Interactive comment on “Effects of a deep rooted crop and soil amended with charcoal on spatial and temporal runoff patterns in a degrading tropical highland watershed” by H.K.

Bayabil et al.

General comments

Figure G1. Average root depth gravimetric moisture content of plots with different treatment

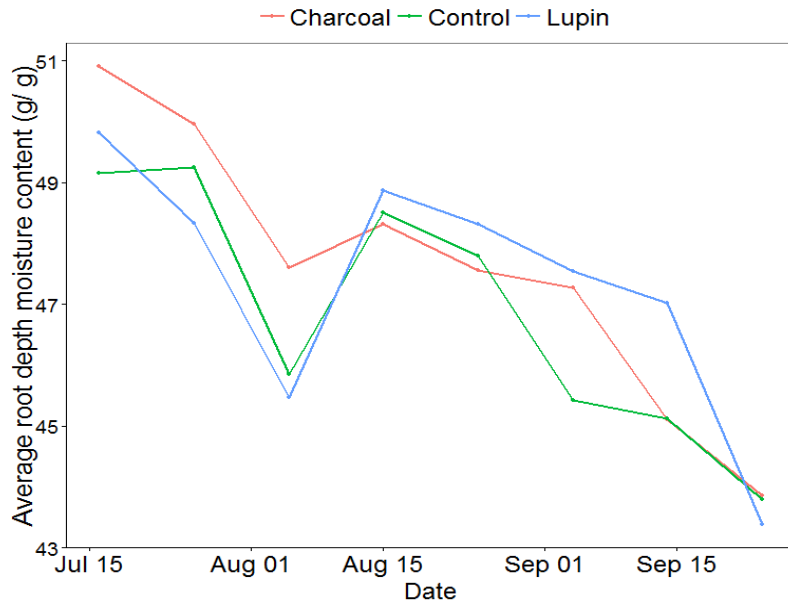
Page 15, lineS 1-3. You mention soil moisture in the abstract. I think this should be shown - at least in the supplementary material.

We agree with the suggestion, and have included soil moisture readings as Supplementary material G.

Supplementary material G: Soil moisture content
